VOLVO PENTA

Service Bulletin

Power Steering Hoses

4.3L, 5.0L & 5.7L

Adjusting Power Steering Hoses for Maximum Clearance

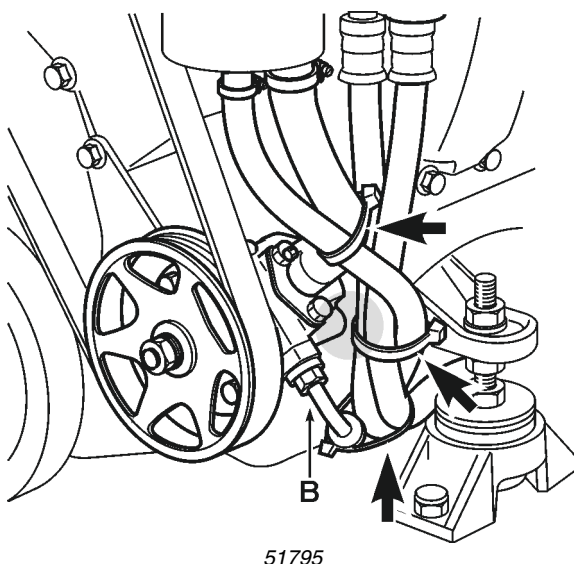
Volvo Penta has discovered that on some engines the power steering oil hoses rub against the bolt **A** on the back of the power steering pump, resulting in wear and ruptured hoses. Prior to delivery or during the next scheduled service, please be sure to check the positioning of all hoses that pass close to the back of the power steering pump and, if necessary, make the adjustments described below.

1. Use tie straps in the areas shown by the arrows to keep hoses as far away as possible from bolt **A**. See shaded area in bottom illustration for location.
2. Should it be deemed necessary (for additional clearance), you may adjust high pressure line **B** such that it maximizes amount of space between bolt and oil hoses.
3. If high pressure line is adjusted, it must be torqued to 20–26 ft. lb. (27–35 Nm).
